AMENDMENT OF SOLICITATION/MODIFICATION OF CONTRACT			1. CONTRACT I D CODE		PAGE OF PAGES	
					1	9
2. AMENDMENT/MOD NO. 02		3. EFFECTIVE DATE See Block 16c		4. REQUISITION/PURCHASE REQ. NO.		5. PROJECT NO

14. DESCRIPTION OF AMENDMENT/MODIFICATION (Organized by UCF section headings, including solicitation/contract subject matter where feasible.)						
The purpose of Amendment 02 is to answer questions submitted in response to the solicitation. All other terms and conditions of the IFB remain unchanged.						
Except as provided herein, all terms and conditions of the document referenced in Item 9A or 10A, as heretofore changed, remains unchanged and in full force and effect.						
15A. NAME AND TITLE OF SIGNER (Type or print)			16A. NAME AND TITLE OF CONTRACTING OFFICER Michael Lonchambon, Contracting Officer			
15B. CONTRACTOR/OFFEROR (Signature of person authorized to sign)		15C. DATE SIGNED		16B. UNITED STATES OF AMERICA  (Signature Of Contracting Officer)		16C. DATE SIGNED 6/23/09
NSN 7540-01-152-8070 PREVIOUS EDITION UNUSABLE

Official Responses to Questions Submitted for Upgrade Auxiliary Chiller Plant, Building 28 Solicitation NNJ09233335E

SKM-28-61.1

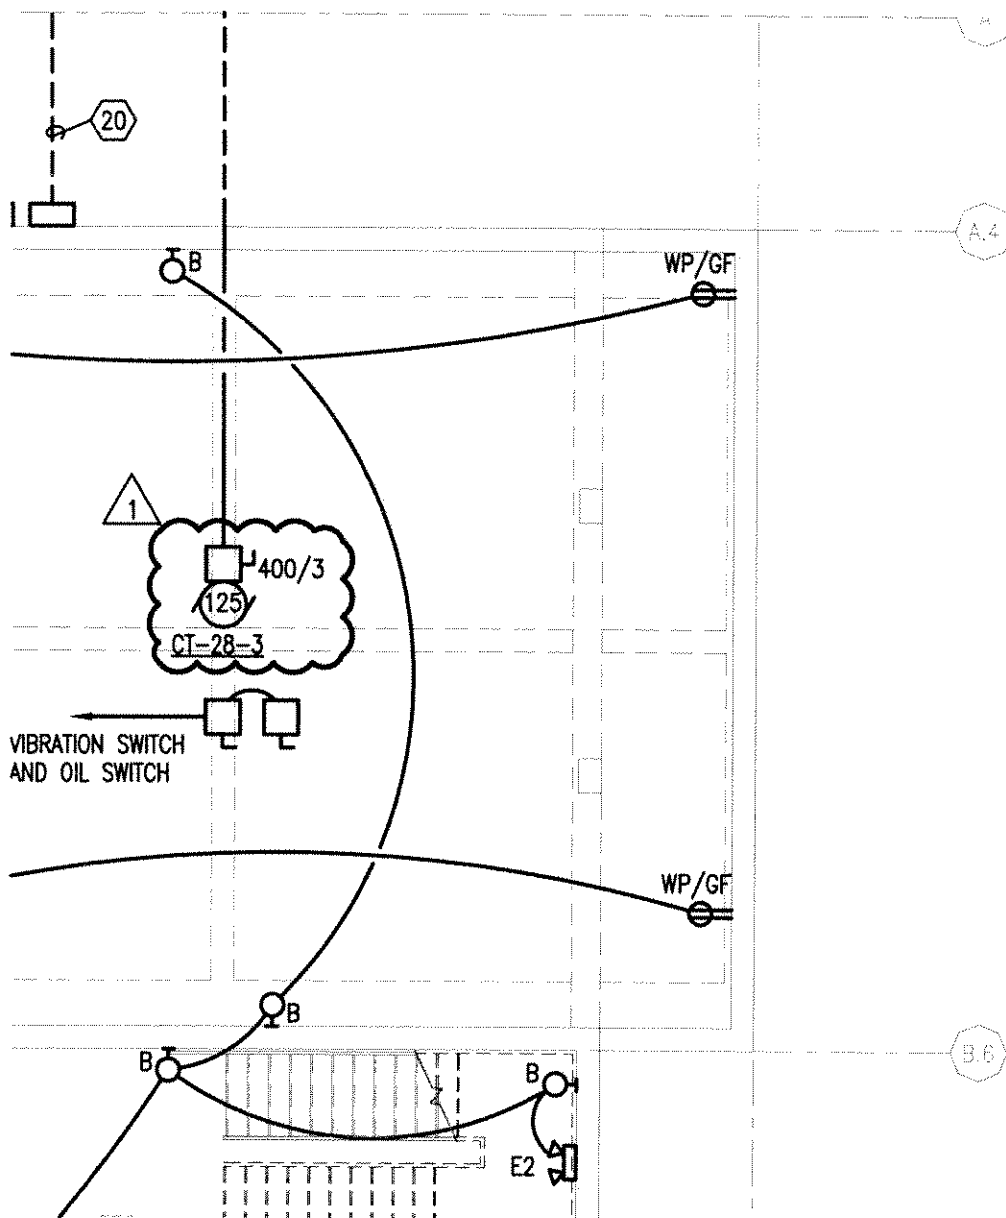
Question 55:	Is the motor size and electrical service correct for the cooling tower fan motor?
Response 55:	<i>No, the sizing has been corrected. Revised sketches, which identifies the material to be replaced, are provided with this amendment.</i>

MARK NUMBER	TOTAL CAPACITY (TONS)	AMBIENT DB/WS TEMP (DEG F/DEG F)	CONDENSER WATER DATA			QUANTITY	FAN DATA			BASIS OF DESIGN	NOTE
			FLOW (GPM)	E W T (DEG F)	L W T (DEG F)		AIRFLOW (CFM)	HP	V/PH		
CT-28-3	2000	95/80	6,500	96	86	1		125.0	48/3	COMPOSITE COOLING SOLUTIONS	1
